CERTIFICATE OF APPROPRIATENESS

Applicant: Rafael Reyes for Daniel Reyes, owner

Property: 7931 Glenview Drive, lot 9, block 2, Glenbrook Valley Section 1 Subdivision. The property includes a historic 1,761 square foot, one-story wood frame single-family residence and a detached garage situated on a 14,960 square foot (117' x 136') interior lot.

Proposal: New Construction – Construct a detached carport next to an existing non-contributing detached garage at the rear of the lot. A previous application was denied at the October 2014 HAHC meeting. This proposal lowers the overall height to 8' from 10' and moves the structure 3' to the west so that it does not overlap the existing detached garage.

SOUTH ELEVATION – FRONT FACING GLENVIEW DRIVE

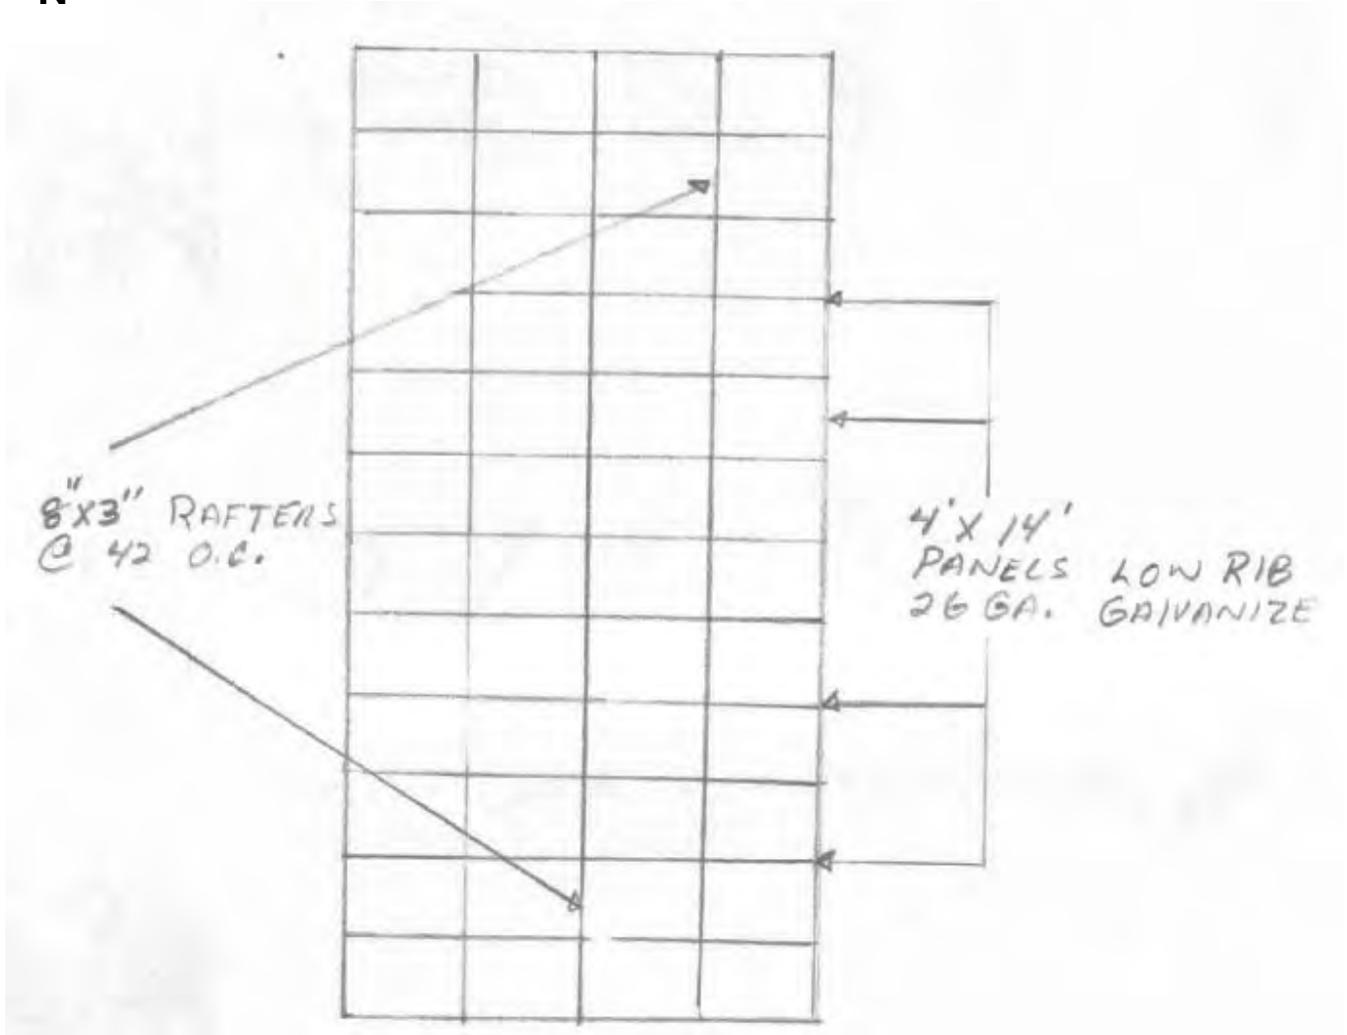
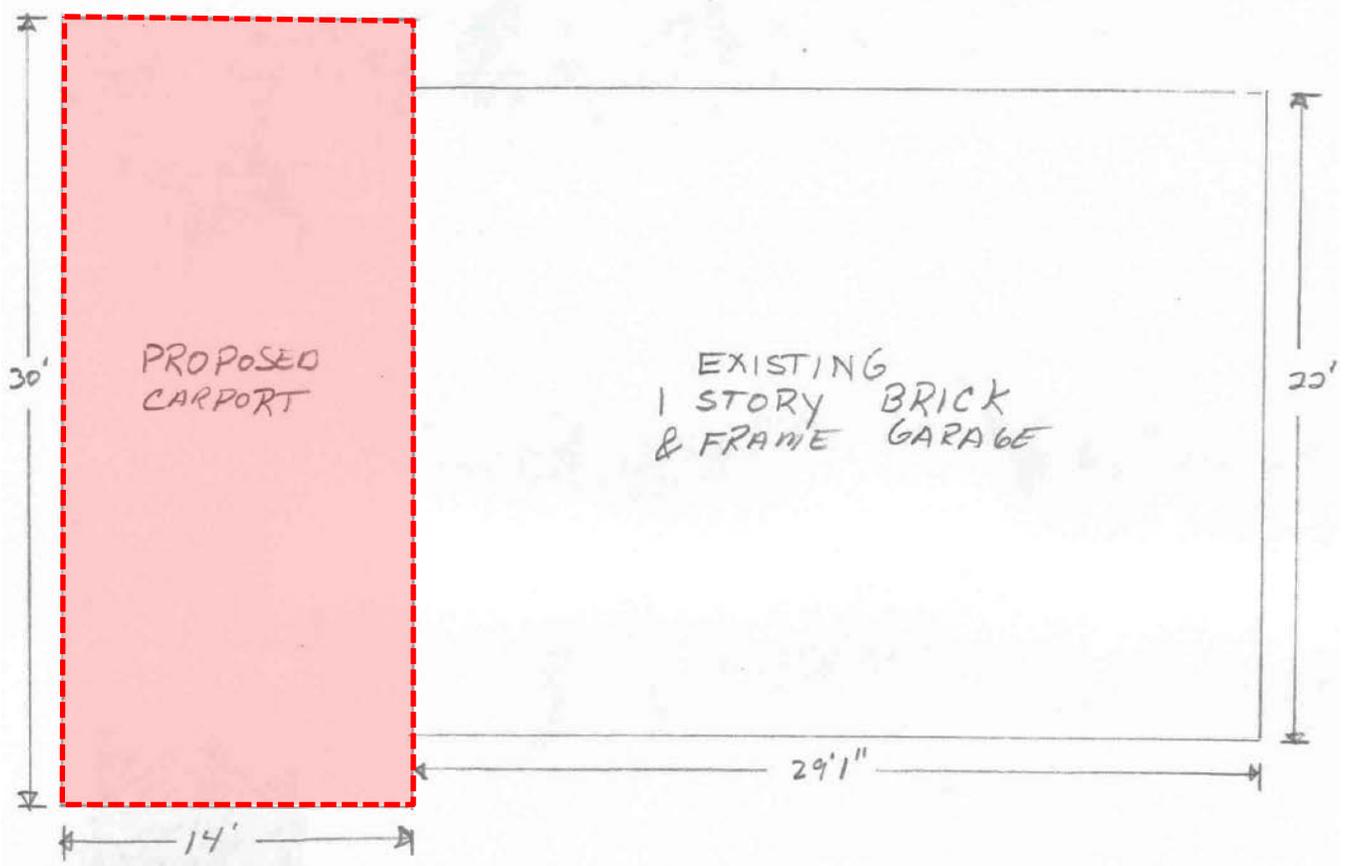
7931 Glenview Drive: The work is complete and the scale of the carport is misleading in the application.
